HISTORIC AND DESIGN REVIEW COMMISSION

HDRC CASE NO: 2018-597
ADDRESS: 727 N FLORES ST
LEGAL DESCRIPTION: NCB 16821 BLK 1 LOT 2 FOX TECH HIGH SCHOOL
ZONING: D,RIO-7A
CITY COUNCIL DIST.: 1
APPLICANT: RVK Architects
OWNER: San Antonio ISD
TYPE OF WORK: Construction of a new administration building
APPLICATION RECEIVED: November 16, 2018
60-DAY REVIEW: January 15, 2018

The applicant is requesting conceptual approval to construct a new 3-story, 14,000 square foot administration building. The project will also include modifications to existing hardscaping and landscaping.

VIEW ON CAMAROON LOOKING TOWARD TRACK

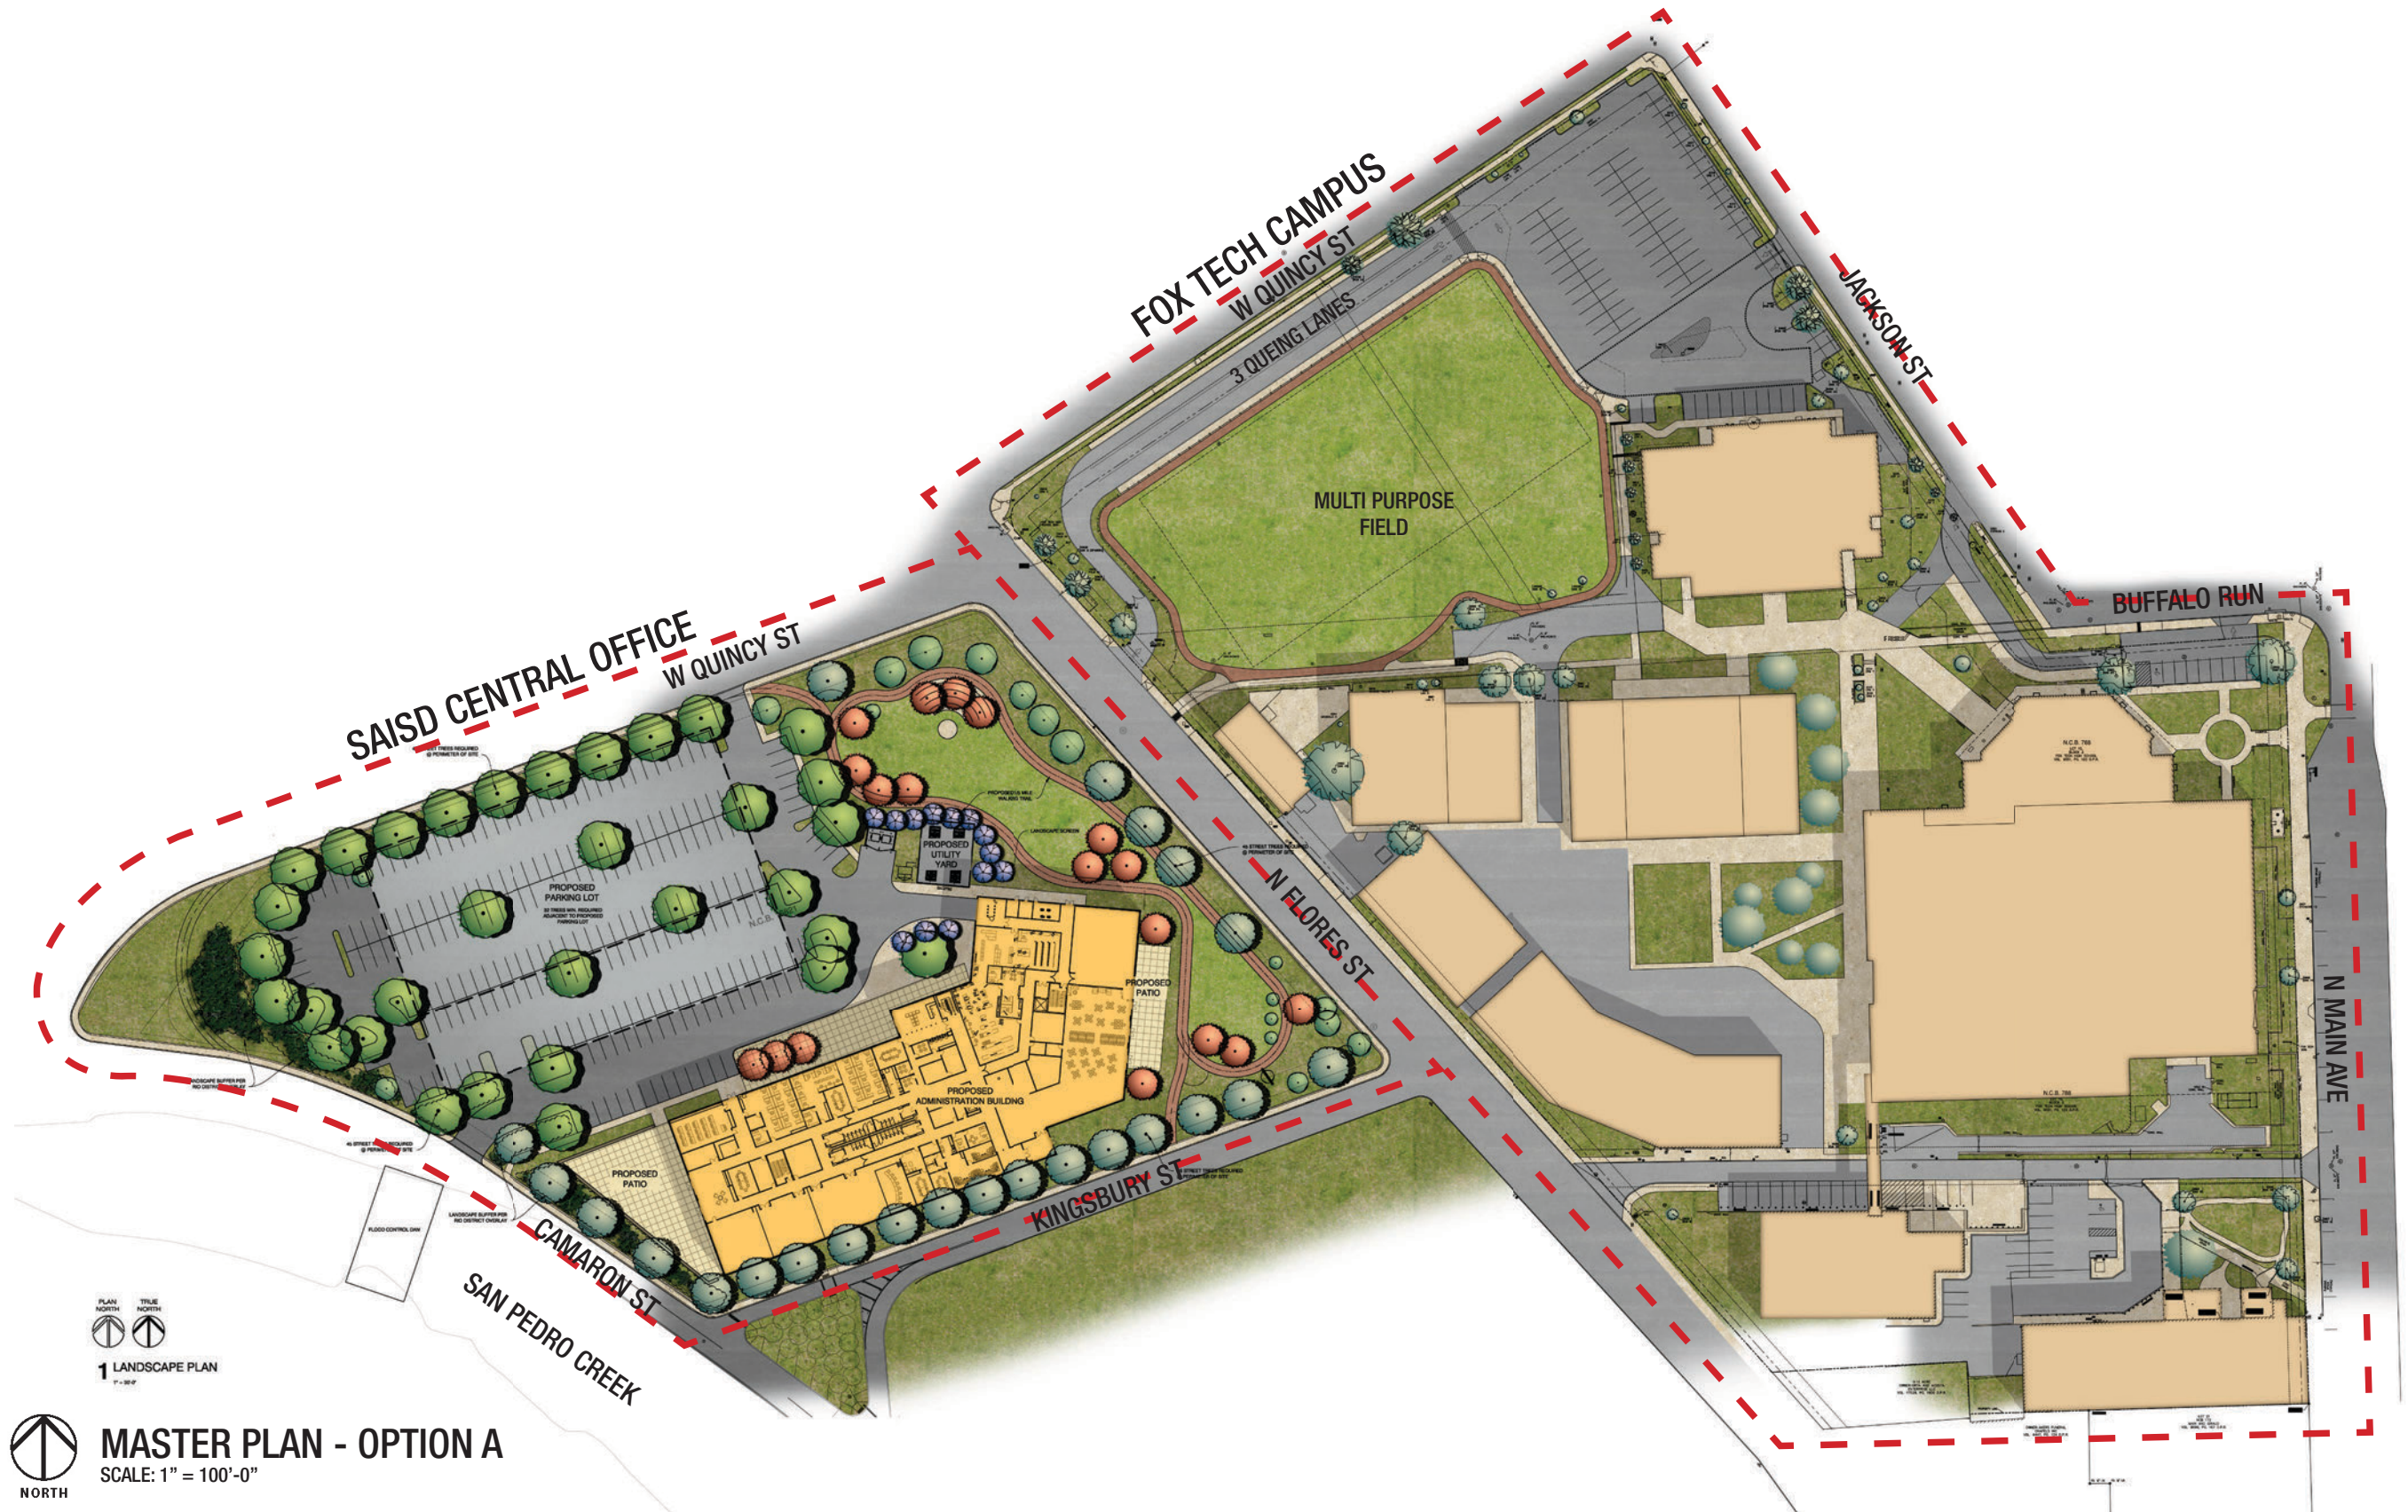
- k. **SIGNAGE** – The proposed renderings indicate potential locations and designs of building signage. The applicant is required to submit a comprehensive signage plan for final approval or in a subsequent application.

ELEVATION NORTH

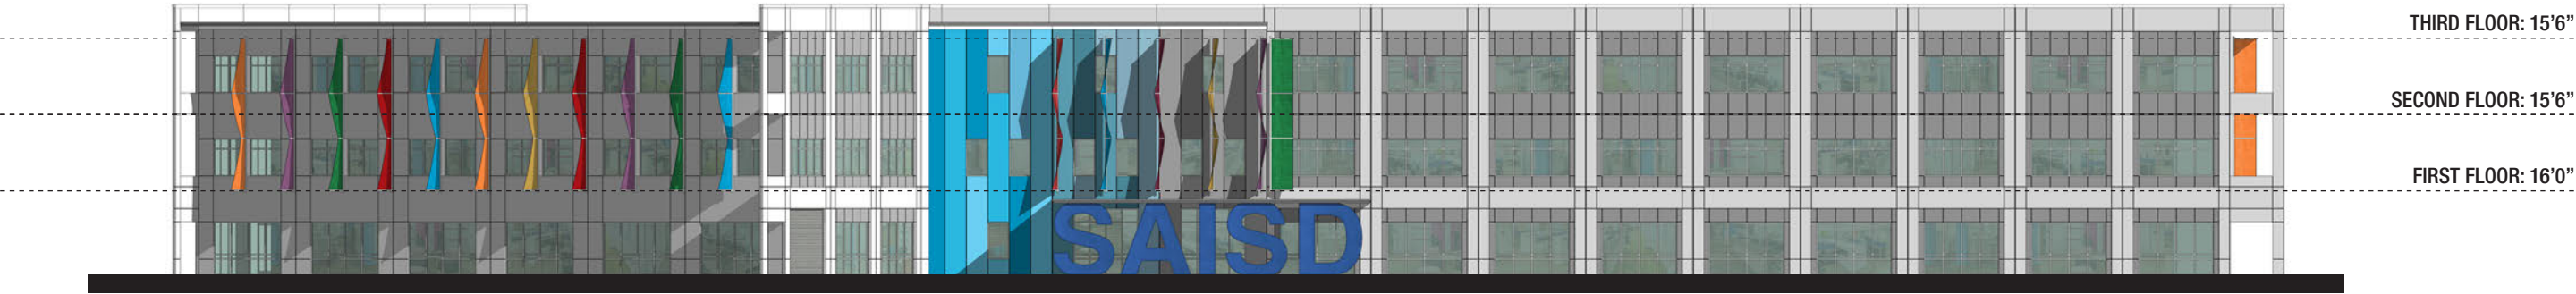
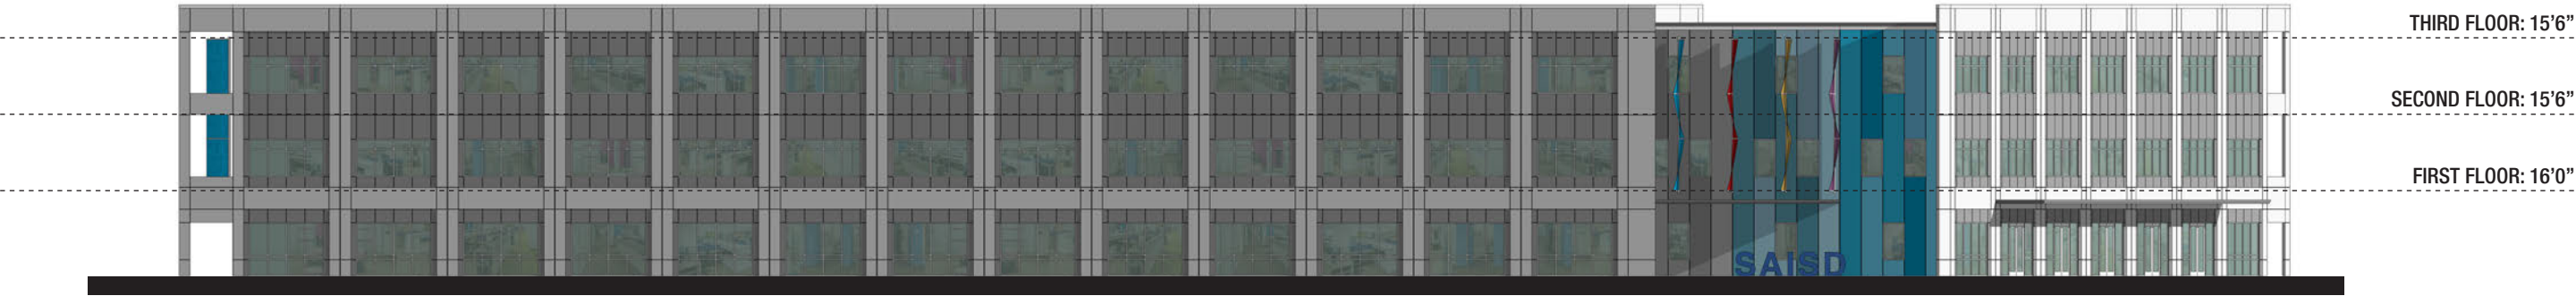
- e. FENESTRATION – The applicant has proposed a 3-story structure with multiple fenestration and opening design strategies. The south, north, east, and west facades will feature long, horizontal expanses of windows. The ground floor will feature metal storefront configurations. The Guidelines for RIO-7A stipulate that a building should have human scale and facades should be broken down visually, as to not exceed 90 feet in continuous length per segment. Staff finds the proposed fenestration conceptually appropriate.

- g. MATERIALITY – The façade of the structure is proposed to be of tilt wall construction. A simple tilt wall expression is proposed for the north and south facing facades, which will be painted white with recessed dark gray panels to include additional reveals similar to metal panels. All elevations will partially feature vertical sunshade devices in various school colors. The applicant has indicated that the exact materiality of these sunshades is being explored and may be metal or fabric. The proposed entries on the north and south will be accentuated with wall extensions and large roof overhangs. The applicant is responsible for complying with the UDC requirements for materials for RIO-7.
